# UNITED STATES PATENT AND TRADEMARK OFFICE

APPLICATION NO.	FILING DATE	FIRST NAMED INVENTOR	ATTORNEY DOCKET NO.	CONFIRMATION NO.
10/554,172	10/24/2006	Jacobo Mugica Miguel	15053.0016USWO	7642
23552	7590	10/07/2008		
MERCHANT & GOULD PC P.O. BOX 2903 MINNEAPOLIS, MN 55402-0903			EXAMINER NGUYEN, TAM M	
			ART UNIT	PAPER NUMBER
			3764	
			MAIL DATE	DELIVERY MODE
			10/07/2008 PAPER

### Office Action Summary

## **DETAILED ACTION**

FIG. 10

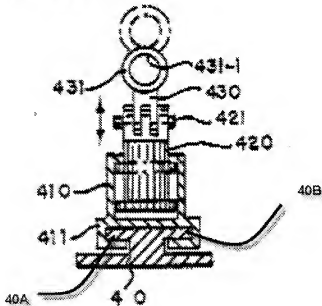
6. As to claims 1, 3 and 8, Kim discloses a training bench having a framework that includes two or more longitudinal bars (200R,200L), rotational rollers or a belt (250) located between the bars and a central support, that can be connected to a pedal set casing of a bicycle, that: includes a platform (411) connected to the framework with transverse bars or guides (40A,40B) on which the platform can move in a free or regulated manner and an anchoring system (410,430) serving as a holding base for holding a vertical column (420) and providing a support means for the frame of a bicycle on a free end of the vertical column and the anchoring system acting as an absorption member to control the movement of the bicycle relative to the platform and framework (see Fig. 10 below and Figs. 9 & 11). Kim does not disclose that the anchoring system is elastically deformable. Lim et al. disclose an exercise device having a deformable anchoring system for supporting a bicycle wherein the anchoring system includes a pair of elastically deformable springs (180) (see Fig. 1). At the time of the invention, it would have been obvious to a person of ordinary skill in the art to combine Lim's springs with

Kim's anchoring system to provide a means for biasing the vertical column back to center following side to side swaying motion due to pedaling of a bicycle on the bench during exercise to enhance the outdoor riding simulation experience.
